SUBMISSION TO SYDNEY OLYMPIC PARK MASTERPLAN (2016 REVIEW) AND AMENDMENTS TO SEPP (STATE SIGNIFICANT PRECINCTS) 2005

Thank you for the opportunity to provide comments on the Sydney Olympic Park Master Plan (2030) Review 2016. The letter is prepared by Urbis on behalf of our client, Austino Property Group (Austino).

Figure 3 – Existing Master Plan Controls Building Heights

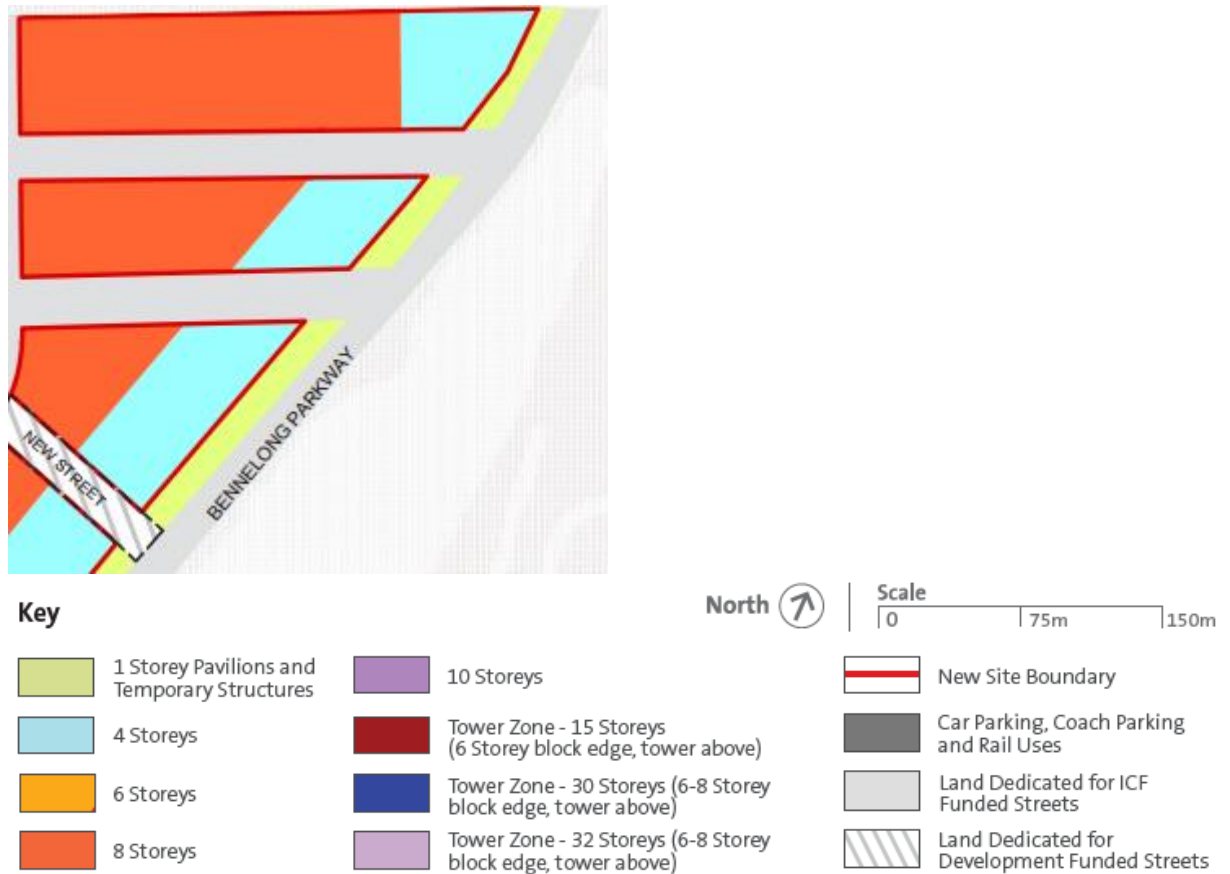
The building height plan contained within the Precinct Controls section of the Review sets out the updated maximum height limits for the precinct. Figure 3 overleaf is an extract from the existing Parkview Precinct height limit controls in the present Master Plan.

We request that the tower zone height limits within the precinct are extended onto Lot 60A and 60B to provide the opportunity for the erection of new towers up to 15 storeys with 6 storey block edges at this location. This is illustrated on the right hand side plan of Figure 4, with the key for this included in Figure 3 overleaf.

Figure 4 – 2016 Proposed and Austino Proposed Amendment Building Heights Plan

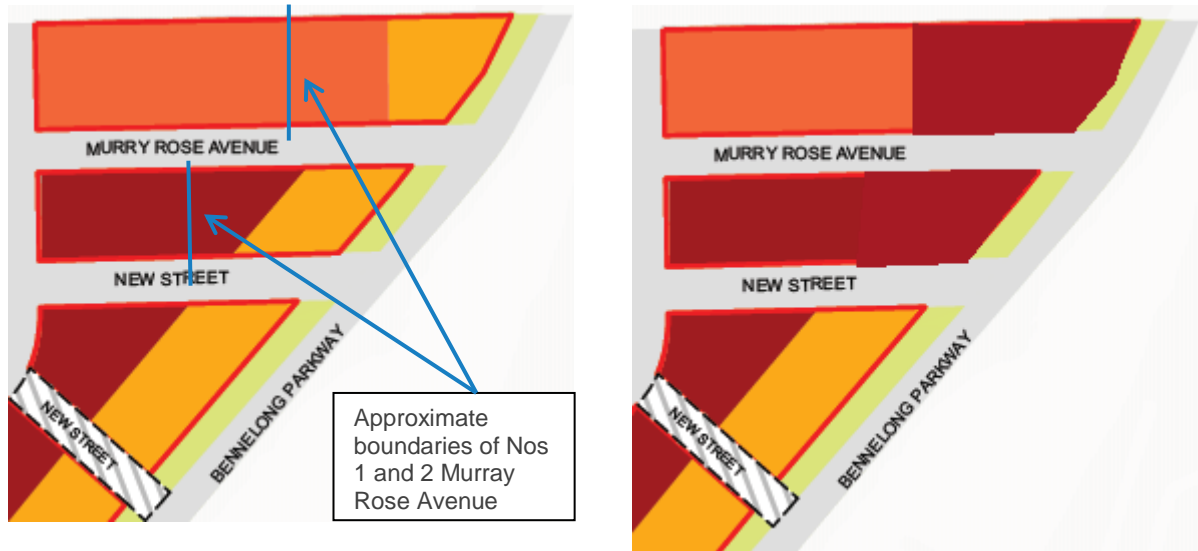
In addition, Figure 4 on Page 6 of this letter identifies the 2016 Master Plan Review position and the Austino proposed amendment to the height of building controls. It is evident that there is a 'tower storey zone' running along the centre of the precinct on the 2016 Review Master Plan (illustrated in dark red) which forms a 'spine' of taller development through this part of the precinct. The height limit for these blocks is 15 storeys for the tower, with a six storey block edge. It can also be seen from the plan that this spine does not extend northwards beyond Murray Rose Avenue to the final block in this corner precinct.

Our reasons for the changes to building height onto Lot 60A and 60B are summarised below:

1. **Urban design principles not undermined** – the masterplan places tall tower forms along the two boulevards. For the Parkview Precinct the heights actually do not consistently step down east of Australia Avenue – they are actually quite varied. At the southern end of Parkview, Site 68 creates a 'marker' tower form at 97metres in height. Our proposal is not seeking to create another tall marker form, but rather ensure the edge of the residential precinct is signalled by a building form higher than a lower street-edge form providing a strong block-definition to this north eastern side of Parkview Precinct.

1. The Building Heights are increased to 15 storeys including a six storey podium at northern part of Parkview Precinct, in order that new residential towers can be developed at 1 and 2 Murray Rose Avenue which benefit from the high levels of amenity. This will enable a better realisation of the potential of the FSR on Lot 60A and 60B which would otherwise be constrained by the height restrictions.

It is therefore requested that **Figure 5.41** of the draft Masterplan is amended to extend the Tower Zone such that it continues further north to the edge of the park and fronts onto Bennelong Parkway at the intersection with Murray Rose Avenue, in order to capture the significant opportunities that this site presents. This amendment should also be captured in the SEPP Plan Alteration for **Heights of Building Map**.

Figure 5 – Plans Illustrating Extent of Site

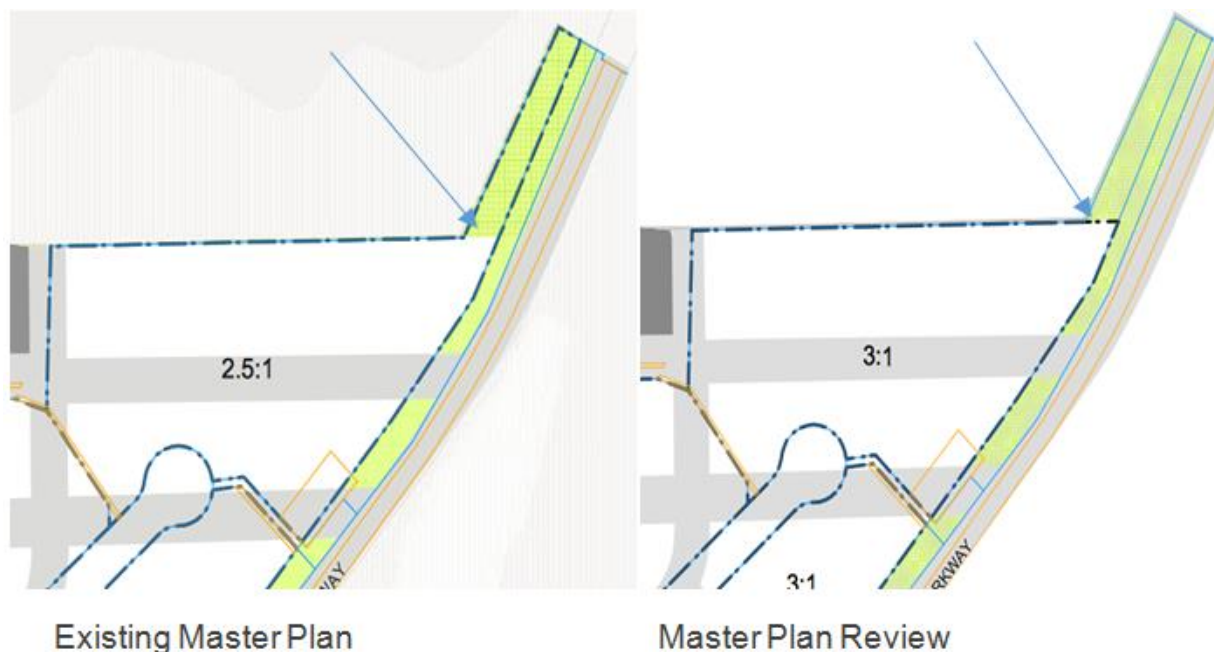
There is a critical point of clarification in relation to the extent of the boundary for the purpose of calculating FSR. Nos.1-5 Murray Rose Avenue (Lot 88 DP 870992) has an area of 24,515sqm with an overall FSR of 2.5:1 under the current Master Plan, Figure 5.39.

As the Figure 5 below illustrates, the strip of land which extends northwards along the Bennelong Parkway frontage forms part of the same lot under the existing Master Plan. The Master Plan Review appears to exclude this strip of land which totals 1,570sqm, reducing the area for FSR purposes to 22,945sqm. This in effect reduces the proposed FSR of 3:1 to 2.79:1, meaning an FSR of 3.2: would be needed to compensate for the reduced area.

It has long been agreed with Sydney Olympic Park Authority (SOPA) that this land is part of the site for the purposes of calculating FSR and there is nothing in the Review document relating to this being one of the amendments.

Therefore, in order to avoid ambiguity, we request that the site area for FSR purposes be maintained at 24,515sqm. As such, the area within the boundary as illustrated in Figure 5.39 Parkview Precinct Site Floor Space Ratios Plan should not be amended, other than the FSR increase, from that represented in the existing Master Plan.

2. **Figure 5.39** Parkview Site Floor Space Plan Ratios Plan boundary as documented in the existing Master Plan should not be amended, as it relates to the area for 1-5 Murray Rose Avenue (lot 88 DP870992) thus maintaining the existing area of 24,515 square meters for the purposes of FSR.
3. Update the notation of the through site links on Sites 60A and 60B to be 18m to reflect the existing situation. This avoids ambiguity in the future development of the residential portion of these sites.
